Sheet E1.1.

DUNELAND SCHOOL CORP.
CHESTERTON HIGH SCHOOL/MIDDLE SCHOOL
CHESTERTON, INDIANA

Drawing Title:
LIGHTING PLAN - UNIT 'A'

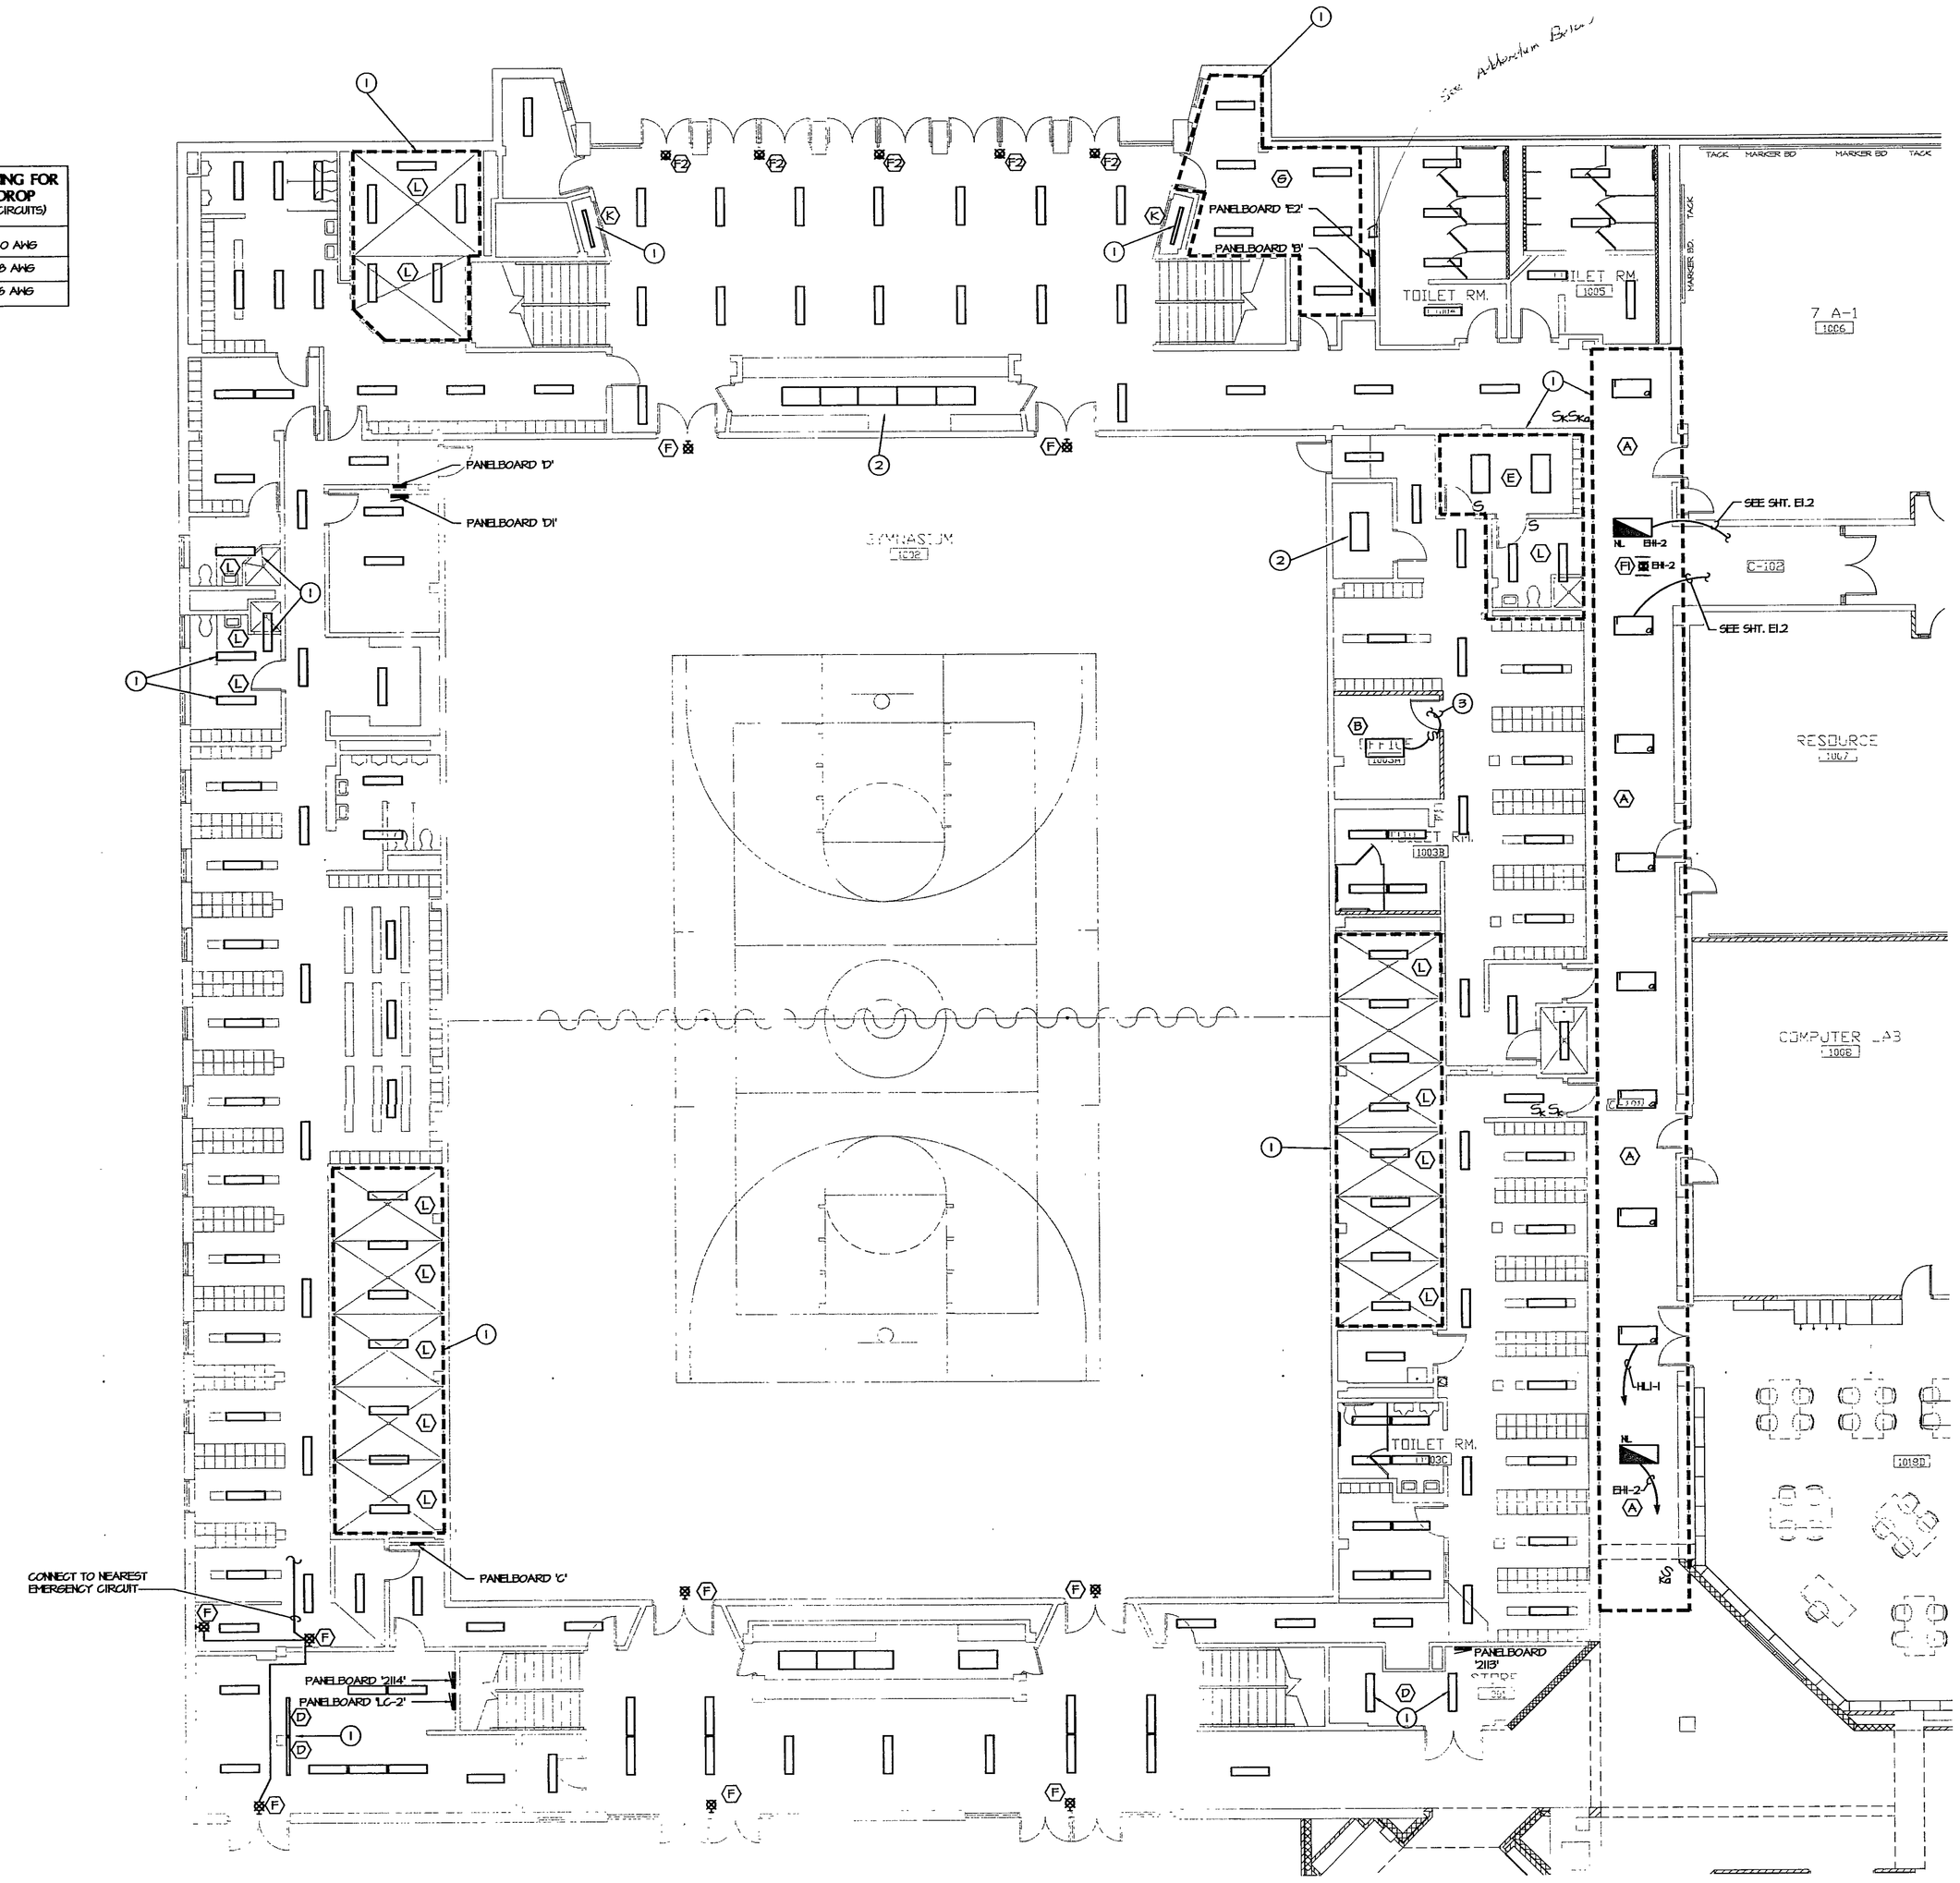
a. Provide a lighting contactor equal to Square D #8903-LG30-V02 with normally closed contacts. Coil shall be connected to spare 20A, 120V circuit on Panel 'B'. Existing gymnasium incandescent emergency lighting fixtures connected to Panel E2 shall be routed through this contactor prior to connection to Panel E2
